**PLANNED UNIT DEVELOPMENT
& SUBDIVISION STAFF REPORT****Date: May 3, 2012****DEVELOPMENT NAME**

Charter Southland Hospital

Charter Southland Hospital Subdivision, Resubdivision of Lot 1, Resubdivision of Lots 1 & 2

Planned Unit Development Approval to allow multiple buildings on a single building site, and Subdivision approval to create one legal lot of record.

SITE PLAN

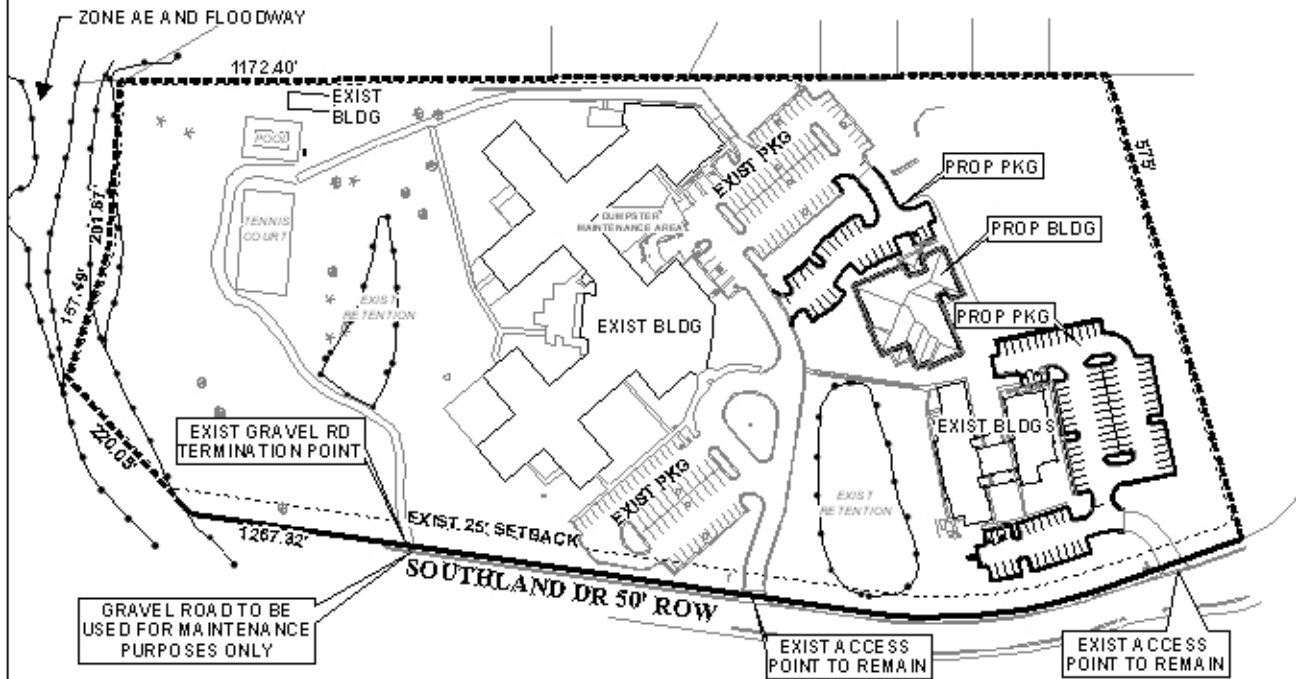
The applicant has submitted a site plan illustrating the placement of the various buildings and amenities, parking, and landscaping and tree plantings. However, there is no table furnished providing parking requirements for the various buildings based on the uses of the buildings; therefore, the site plan should be revised to provide parking requirement calculations. Also, the site plan does not indicate any dumpster locations; therefore, the site plan should be revised to illustrate compliant dumpster locations. As the site is bordered on the North entirely by Leesburg Subdivision, an R-1, single-family residential development, a protection buffer should be illustrated; therefore, the site plan should be revised to illustrate a protection buffer in compliance with Section 64-4.D.1. of the Zoning Ordinance. And as the site is adjacent to R-1

As the Subdivision would require dedication to provide a 60' radius turnaround from the centerline of Southland Drive at its Western terminus, the PUD site plan should be revised to illustrate such a turnaround. And the site should be limited to two curb cuts to Southland Drive with the size, location and design to be approved by Traffic Engineering and conform to AASHTO standards. The existing gravel drive on the Western portion of the site beyond the existing asphalt drive appears to be for maintenance purposes only but its use is not specified on the site plan. The gravel drive should be identified as for maintenance purposes only on the site plan or the site plan should be revised to indicate the drive paved to standards. The site plan indicates the existing access point to Southland Drive for the gravel drive is to be removed; however, the site plan should be revised to indicate termination short of Southland Drive or the installation of some type of vehicular barrier across the drive preventing access to Southland Drive.

Calculations indicate sufficient parking spaces are provided for the various uses on the site. A 6' high wooden privacy fence is indicated as a buffer along the entire Northern boundary with Leesburg Subdivision as well as a 10' buffer strip. The site plan erroneously indicates a 5' minimum building setback line along the North and West boundaries. As these two border residential properties, Section 64-4.D.1. of the Zoning Ordinance requires a 10' protection buffer, and as no structure may be built within such, the minimum building setback line should be revised to 10' in those areas. A note is furnished on the site plan indicating that lighting will be in compliance with Sections 64-4.A.2 and 64-6.A.3.c of the Zoning Ordinance as required.

The gravel drive on the Western portion of the site is labeled as being for maintenance purposes only and a termination short of Southland Drive is indicated. The dumpster location has been specified on the site plan; however, no detail is given to illustrate its compliance with screening and gating. Therefore, the site plan should be revised to furnish a detail of a compliant dumpster enclosure with screening and gates.

No landscaping and tree planting calculations are indicated on the site plan; therefore, the site plan should be revised to provide such, to be coordinated with Urban Forestry due to the extensive wooded areas which would remain on the site.

- 1) revision of the site plan to indicate a 10' minimum building setback line along the North and West Boundaries where the site abuts residential properties;*

- 2) furnishing of a note on the site plan stating that lighting for the site will be in compliance with Sections 64-4.A.2 and 64-6.A.3.c of the Zoning Ordinance;*

- 3) revision of the site plan to illustrate a compliant dumpster location including screening and gates;*
- 4) placement of a note on the site plan stating that the approval of all applicable federal, state and local agencies for floodplain and wetland issues would be required prior to the issuance of any permits;*

- 8) revision of the site plan to provide landscaping and tree planting calculations, to be coordinated with Urban Forestry due to the extensive wooded areas that would remain on the site; and*
